San Pasqual Valley Groundwater Basin Sustainable Groundwater Management Act Technical Peer Review Meeting

Sustainable Management Criteria Projects and Management Actions Water Budgets

January 14, 2021

Sensitivity Analysis Approach to Evaluating Subsurface Inflow (Handout 4)

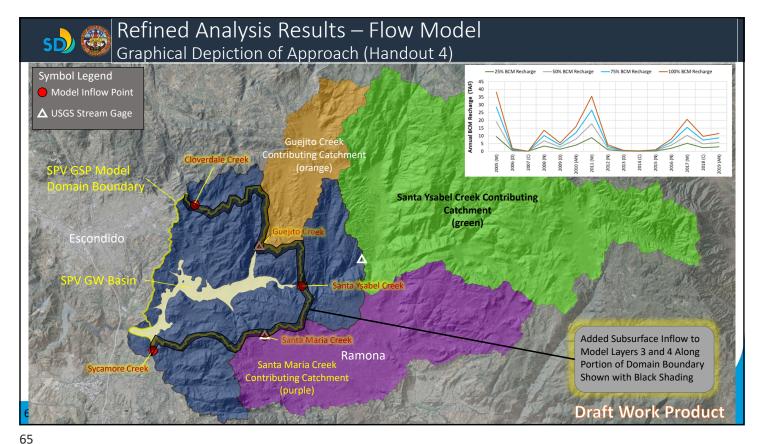
- A concern was raised during the 17-Dec TPR meeting regarding lack of subsurface inflow across no-flow boundaries from contributing catchments surrounding SPV GSP Model domain
- We evaluated five different ranges of subsurface inflow assumptions
 - 0%, 25%, 50%, 75%, and 100% of GW recharge estimated with Basin Characterization Model (BCM) over the historical 15-year calibration period (WY2005 thru WY2019)
 - We assigned monthly subsurface inflows as specified fluxes along the associated domain boundary cells in Model Layers 3 and 4 (deeper bedrock layers)
- Evaluated impacts of these boundary inflows to...
 - GW-level hydrographs at target wells within SPV GW Basin
 - Modeled outflows to Lake Hodges
 - Modeled GW pumping rates at ag wells within SPV GW Basin
 - Modeled change in Basin GW storage during calibration period

- Modeled ag pumping rates are not sensitive to subsurface inflow rates
- Generally, global goodness-of-fit types of statistics worsen with increasing subsurface inflow
 - Local exceptions
 - A small amount (≤ ~25%) of BCM recharge could be tolerated and reasonably fit independent estimates of Lake Hodges inflows
 - Including 25% BCM recharge would also improve fits to GW levels at SP093, SP073, SP072, & SP086, but would slightly compromise fits at other calibration monitoring wells
- Although including subsurface inflow reduces average GW storage depletions, all sensitivity simulations indicate average GW storage deficits over the 15-year calibration period

The modeling team will move forward incorporating 25% BCM recharge as subsurface inflow in Model Layers 3 and 4 along the northern, eastern, and southern boundaries of the SPV GSP Model domain. Doing so will slightly compromise global calibration statistics for GW levels, but will locally improve fits to eastern Santa Ysabel GW levels and inflows to Lake Hodges. Addition of some amount of subsurface inflow also addresses concerns around this topic raised by a TPR member during the 17-Dec TPR meeting.
